MPID 163 - Change to WFPS1- Wind Farm Power Station Provisions

Change to the Grid Code WFPS1 to more accurately reflect the signals, communications and control requirements for wind farms, given our experience of dealing with wind farm communications facilities thus far.

WFPS1 WIND FARM POWER STATION GRID CODE PROVISIONS

Figure WFPS1.2 – Example of Power-Frequency Response Curve.

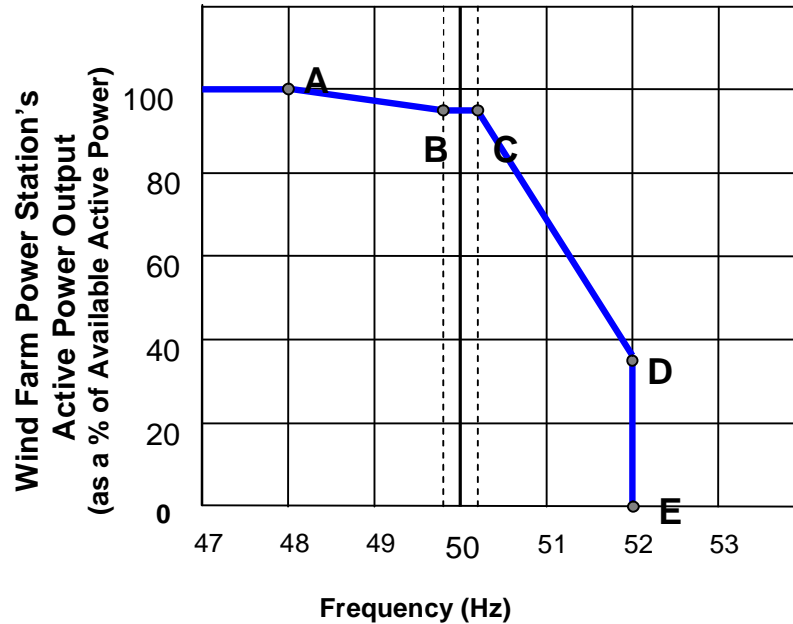
WFPS1.5.2.2.1 The **Frequency Response System** shall have the capabilities as displayed in the **Power-Frequency Response Curve** in *Figure WFPS1.2*, where the power and frequency ranges required for points A, B, C, D, E are defined below in *Table WFPS1.1* and *Table WFPS1.2*.

WFPS1.5.2.2.6 Points 'A', 'B', 'C', 'D' and 'E' shall depend on a combination of the **Transmission System Frequency, Active Power** and **Active Power Control Set-point** settings. These settings may be different for each **Wind Farm Power Station** depending on system conditions and **Wind Farm Power Station** location. These settings are defined in *Table WFPS1.1* below.

Deleted: MW
Deleted: Curtailment

*Figure WFPS1.3 - Locations for **Voltage Regulation** set-point (Z) and the **Power Factor** range (Y). The **HV** side of the **WTG** transformer is (X).*

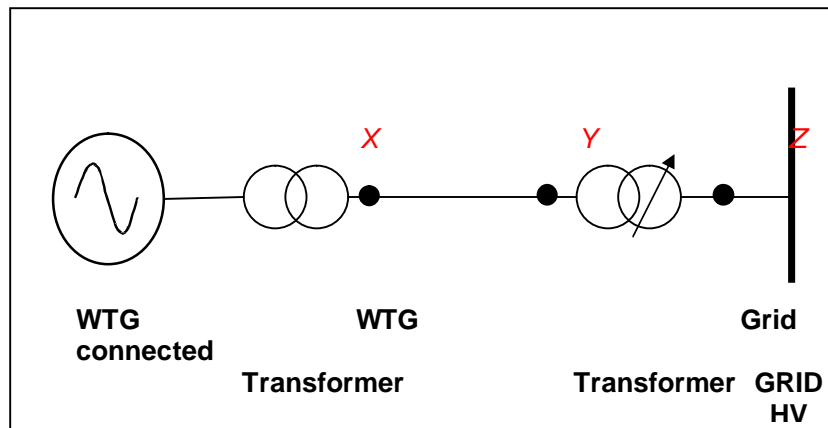
WFPS1.6.2.5 *Figure WFPS1.3* shows the relevant points appropriate to the **Voltage Regulation System** for a **Wind Farm Power Station**. X is the **HV** side of the **WTG** transformer, Y is the **lower voltage** side of the **Grid Connected Transformer** and Z is the **Connection Point**.

Deleted: high-voltage (

Deleted:)

Deleted: low-voltage (LV)

Deleted: high-voltage
